**167 Northumberland Street,
Liverpool**

Traffic Impact Assessment

Issue | 11 May 2021

Figure 6: Proposed site access

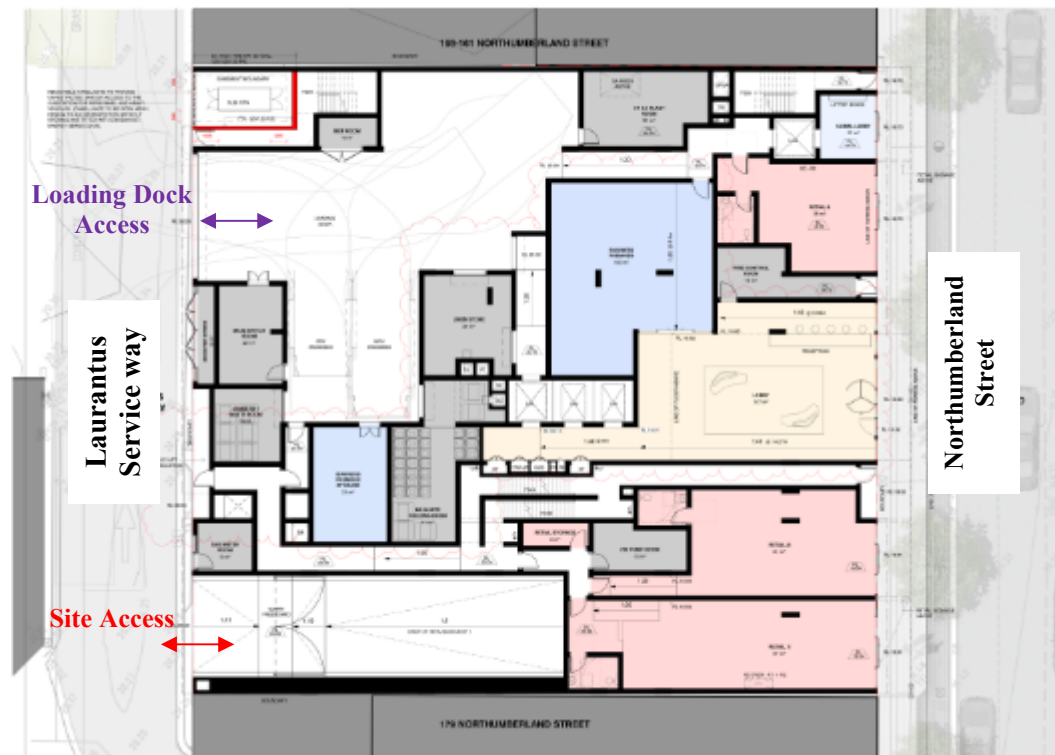
(i) The proposed location of the entrance to the basement car park (i.e. shown on the ground floor plans) is close to the corner of the service way, which is a safety concern due to limited sight distance. Accordingly, the entrance shall be relocated further away from the corner of the service way

The proposed location of the driveway is in compliance with Figure 3.1 of AS/NZS 2890.1:2004 with relation to its location and has been located so that the site can perform efficiently and optimally.

A vehicle within the laneway is also visible approximately 15m from the driveway which is appropriate for the speeds likely in the laneway. This would meet the inferred distances of 15m for conservative 20km/h speeds as interpolated from Figure 3.2 of AS/NZS 2890.1:2004.

However, given the safety concerns raised by Council, the proponent proposes mirrors on the opposing wall and adjacent wall to assist in visibility between the laneway and driveway.

Figure 9 Parking Layout – Basement Level 3

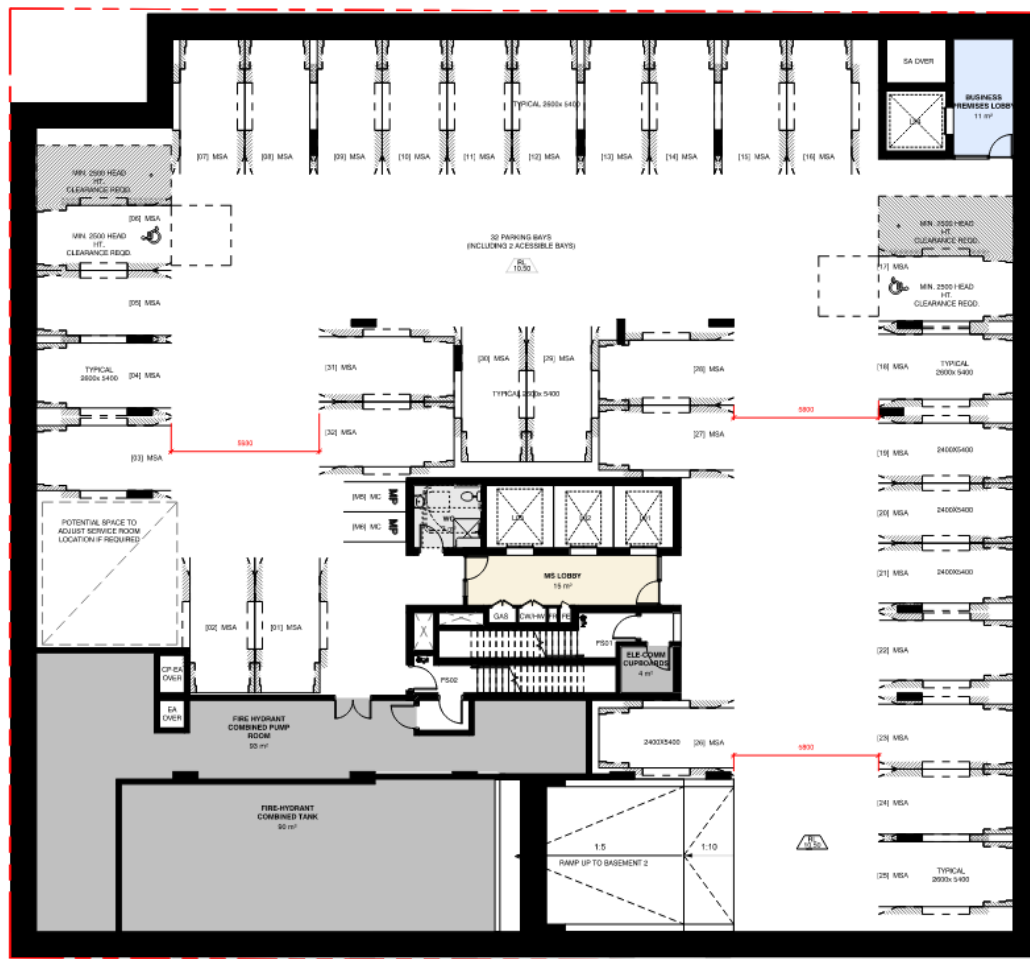
6.	The Section 6.2 of the RtS only provides the requirement of accessible parking space provision. However there is no assessment being undertaken to identify if the adequate accessible parking spaces are provided on site.	<p>21/04/21</p> <p>Accessible parking spaces are illustrated in Figures 7 and 8 of the report. Currently proposed 2 accessible carpark spaces per basement.</p> <p>11/05/2021 Additional basement level (L3) has been incorporated to the project. Refer to Figure 9</p>

Figure 10: Loading vehicle access

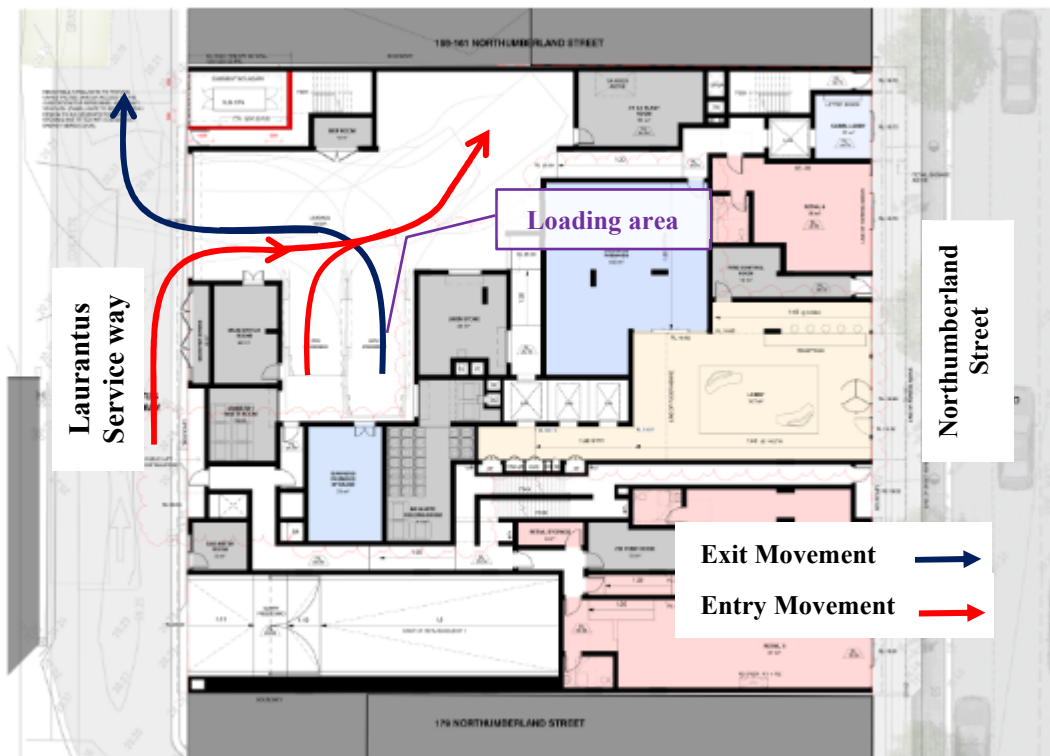
3. Any commercial vehicles that need to access the proposed building loading dock will need to enter Laurantus Service way from Northumberland Street, and navigate to the rear of the proposed building site to gain access to it. If this is a regular occurrence, it will cause delays to any residents that require access to the garage entrances to buildings on Bathurst Street that connect to Laurantus Service way. There is not enough space in that area for large vehicles to easily manoeuvre into any of the existing parking areas of business along the Laurantus Service way, and this situation would not improve in any way with the construction of the 32-storey building.

Swept paths included in this report have been prepared for the loading dock and allow for the entry and exit of large vehicles in a forward's direction from the laneway. Servicing should occur from the lower order road/lane (Laurantus Service way) rather than directly from Northumberland Street. No reversing will occur within the laneway and therefore delays will be expected to be minimal and manageable for residents.
